# SERVICE BULLETIN

M-855

## FOOTREST CHAIN PROTECTOR 1982 XL MODELS

Footrest Chain Protector

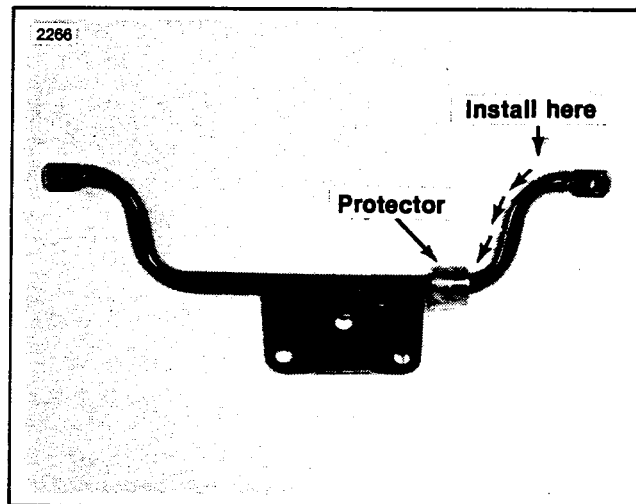
The footrest chain protector, Part No. 50943-82, is designed to prevent contact between the final drive chain and passenger footrest bracket on 1982 XL model motorcycles.

1. See illustration. Using channel locks, install protector on the footrest bracket behind the passenger peg.
2. Locate protector on bracket as shown in illustration. Open section faces the swingarm. This will prevent rotation of the protector.

*Protector conforms to bracket configuration and is self-retaining.*
